## **Documentation of Public Meeting**

North 16-mile Comprehensive Project

CSJs: 0015-09-178, 0015-10-062, & 0015-13-389

### Mobility35: North16 Open House #1 Comment/Response Matrix

# ROADWAY CONFIGURATION

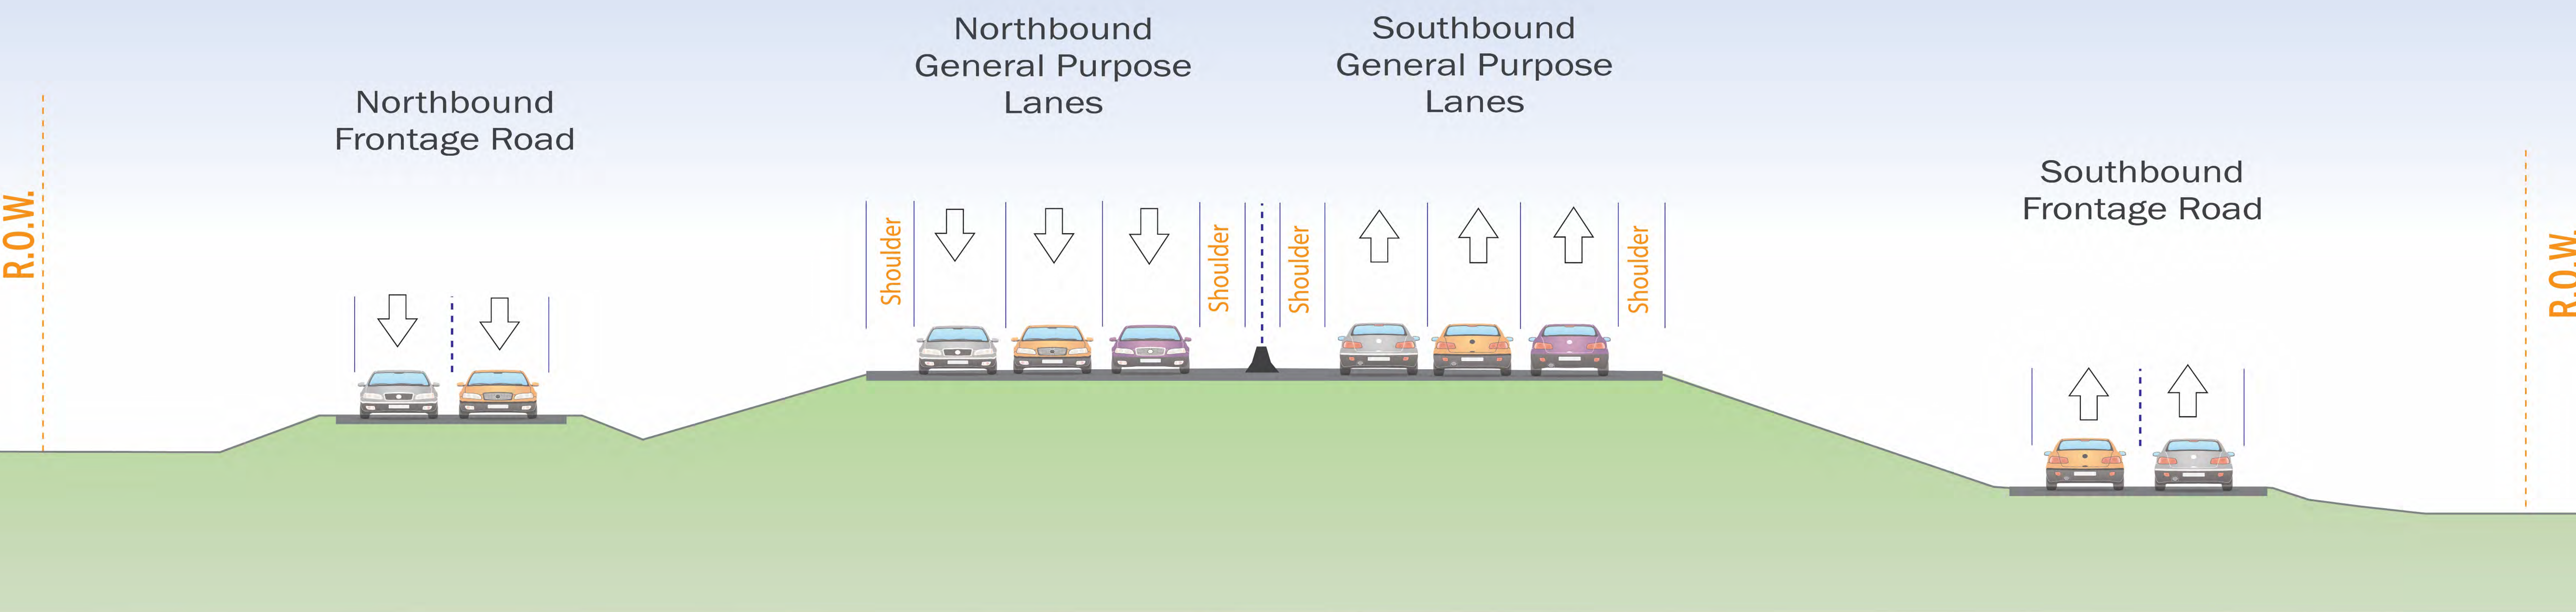
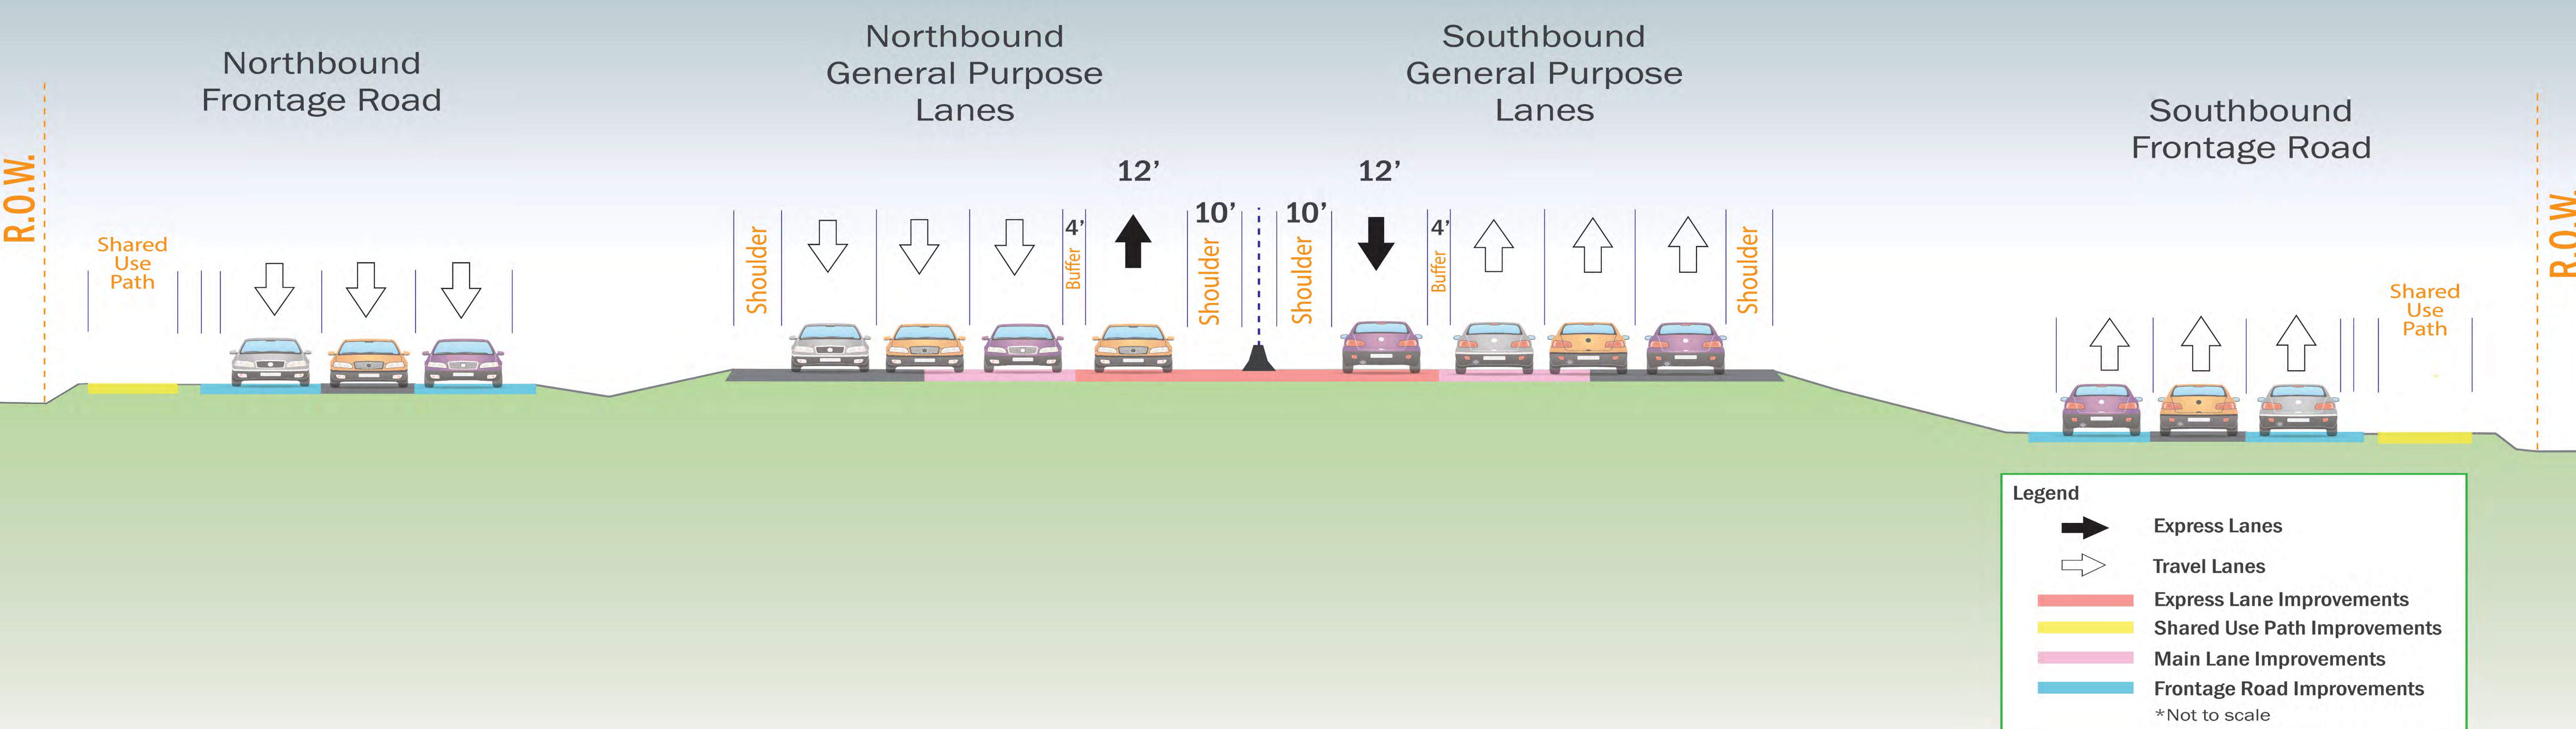
Simultaneously amusing and sad that the cross-section drawing comparing the before and after roadways are marked "not to scale". Is it to avoid showing the narrow "free" lanes and the nice wide toll lanes?
